# Downtown West

Design Standards  
and Guidelines  
*Errata*

April 15, 2021

# ERRATA

FIGURE 5.7: Architectural requirement summary

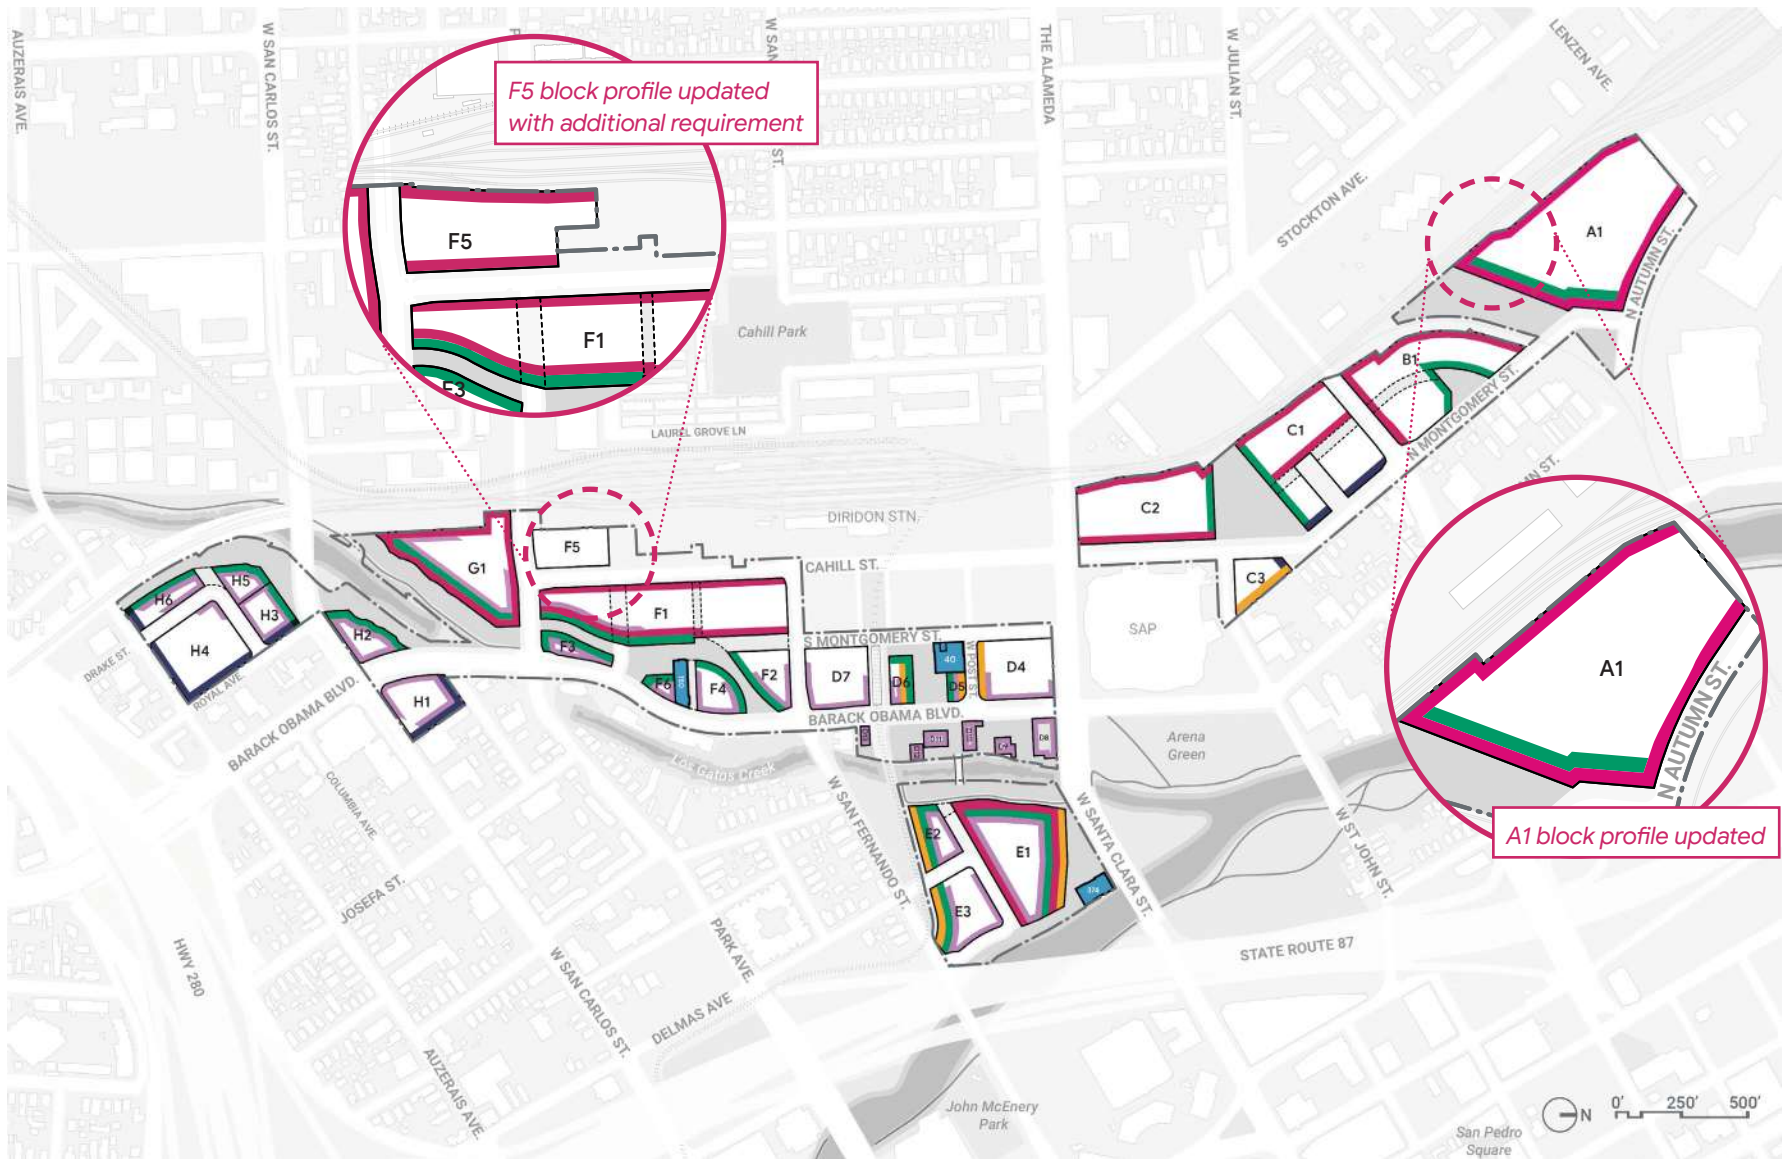
ER_14	170	Buildings	Figure 5.7	Addition of long facade demarcation on F5 east (secondary) and F5 west (primary).
ER_15	171	Buildings	Table 5.1	Addition of long facade demarcation on F5
ER_16	173	Buildings	Figure 5.9	Site boundary changes at F5 and A1
ER_17	176	Buildings	S5.5.7	<p><b>• The existing structure at block D13 shall be replaced by the relocated 35 South Autumn Street (Barack Obama Boulevard) main structure (see S5.15.3). The structure from 35 South Autumn Street shall be relocated within the building footprint of 74 South Autumn (Barack Obama Boulevard) and outside of the 50-foot Los Gatos Creek Riparian Setback.</b></p> <p>• If the property owner elects to demolish any building on blocks D9 <b>or D12, D12, and D13</b>, the property owner is permitted to replace the demolished built area in a new building elsewhere in Creekside Walk. Replacement structures for blocks D9 <b>or D12, D12, and D13</b> shall not encroach into the 50-foot Los Gatos Creek Riparian Setback. Individual replacement structures shall be permitted to exceed the gross square footage of the existing structure in accordance with the square footage limits of additions described below. Replacement structures are subject to applicable standards in Sections 5.6, 5.7, 5.8, and 5.13."</p>

FIGURE 5.30: Primary long facade and secondary long facade locations

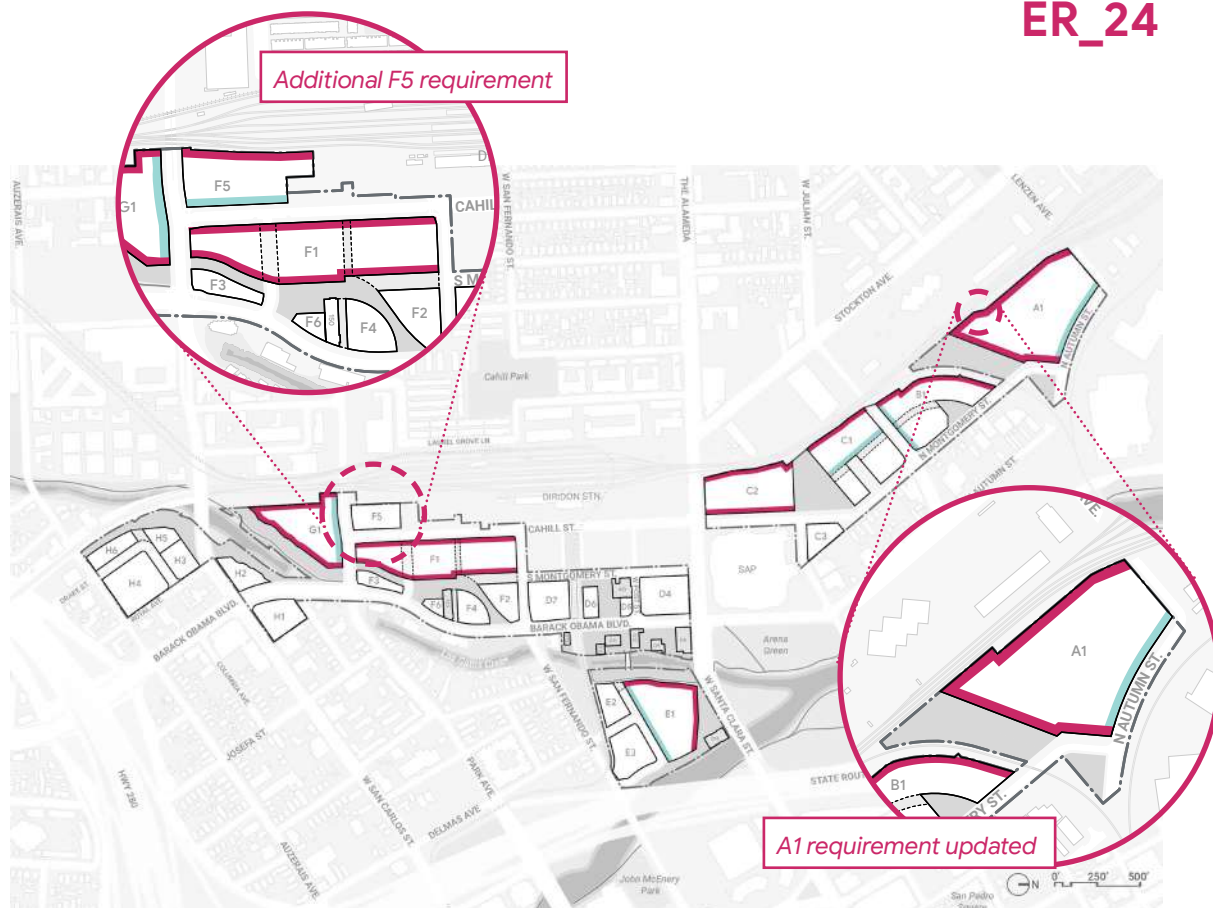
ER_24	202	Buildings	Figure 5.30	Addition of long facade demarcation on F5
ER_25	217	Buildings	S5.15.3	“The main structure of 35 South Autumn Street (Barack Obama Boulevard) — a single family home dating from 1880 located along the west side of Barack Obama Boulevard — shall be relocated to block D13 <b>as a replacement structure pursuant to S5.5.7. within the current building footprint of 74 South Autumn (Barack Obama Boulevard) and outside of the 50-foot Los Gatos Creek Riparian Setback, pending structural feasibility. The relocation of 35 South Autumn (Barack Obama Boulevard) shall be permitted as a replacement of existing structure, a pavilion structure, or a permanent structure (see Section 4.25) within Creekside Walk. The structure shall not be relocated within the 50-foot Los Gatos Creek Riparian Setback.</b> Modification to 35 South Autumn Street (Barack Obama Boulevard), a Structure of Merit, shall not be required to comply with the Secretary of the Interior’s standards.”

FIGURE 6.53: Conceptual off-street parking garages

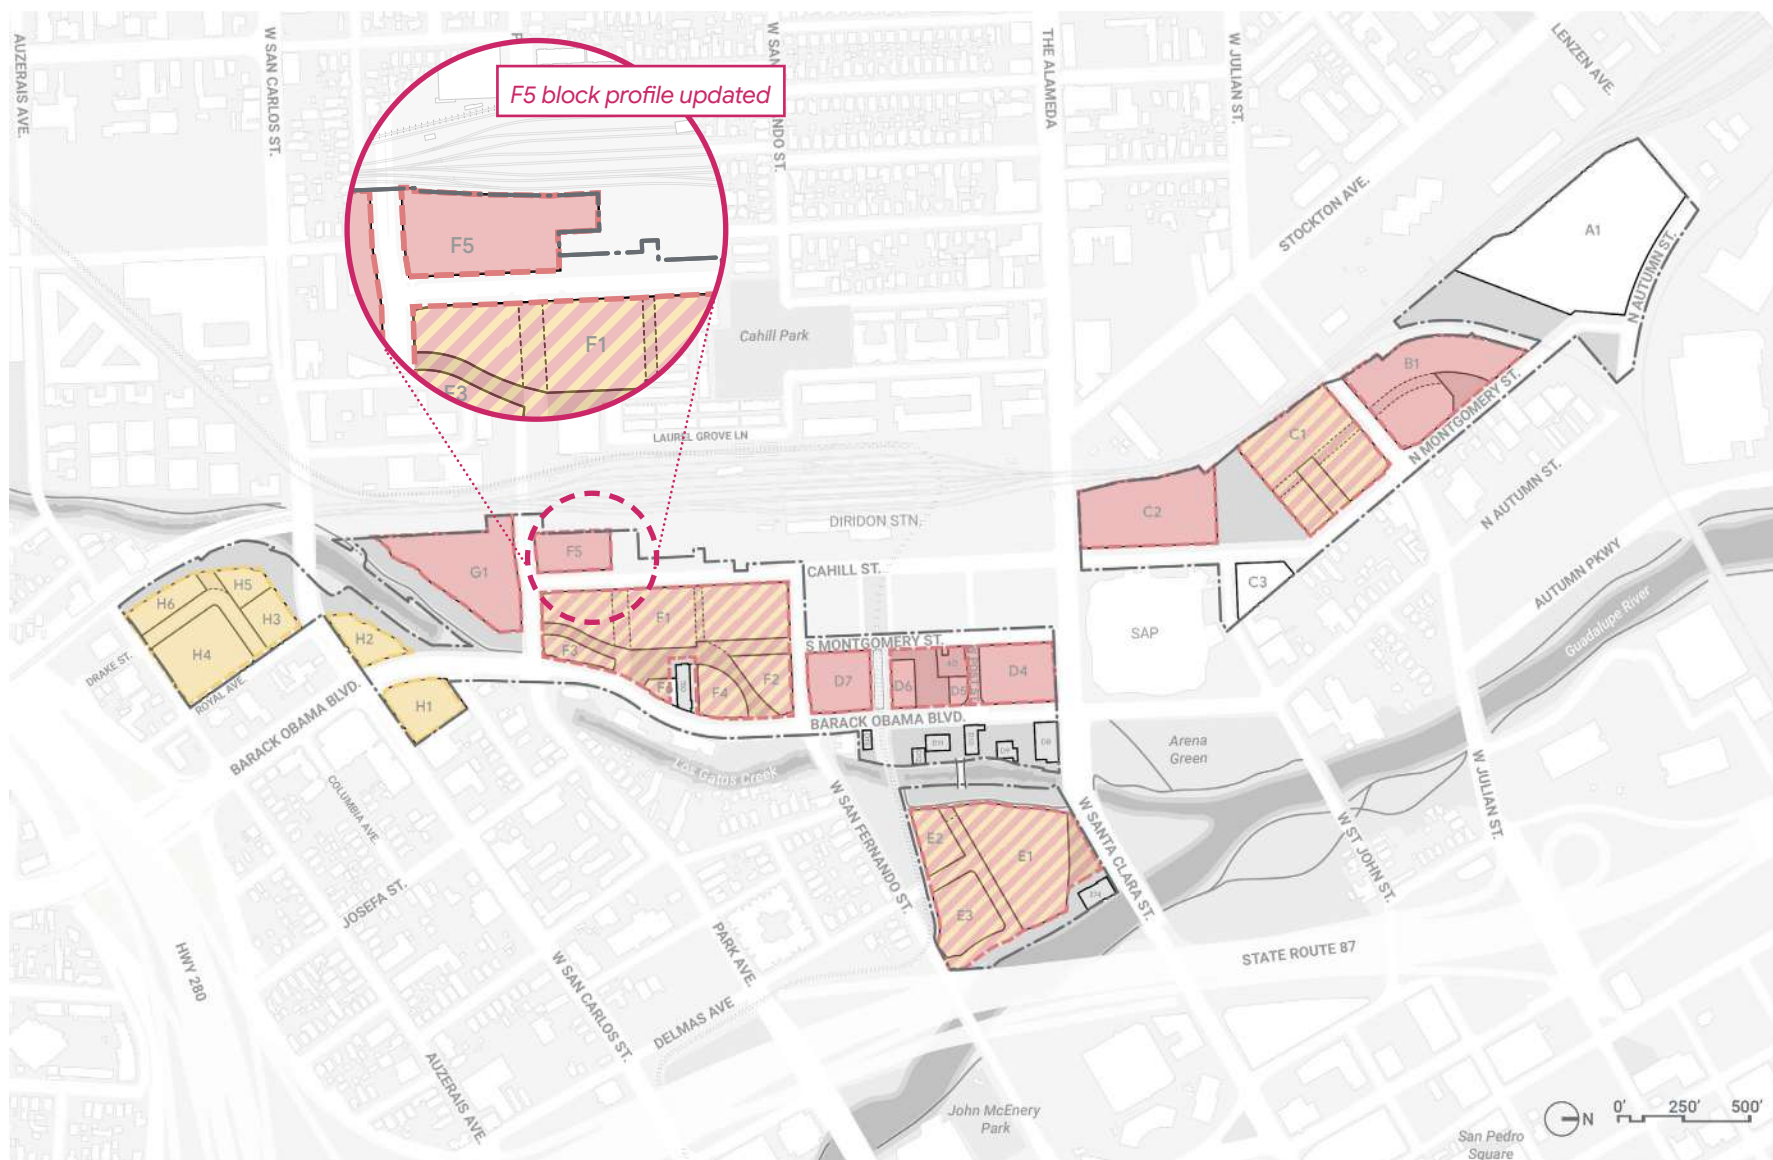
ER_28	297	Mobility	Figure 6.53	Site boundary changes at F5 and A1
ER_29	299	Mobility	Figure 6.54	Site boundary changes at F5 and A1
ER_30	307	Lighting and Signage	S7.3.3	“All open space lighting, <del>excluding lighting for art</del> , shall <del>install lighting that has have</del> a color temperature of less than or equal to <del>2,700</del> <b>2700</b> kelvins. Lighting requirements for art adjacent to a riparian corridor shall follow S7.4.7.”
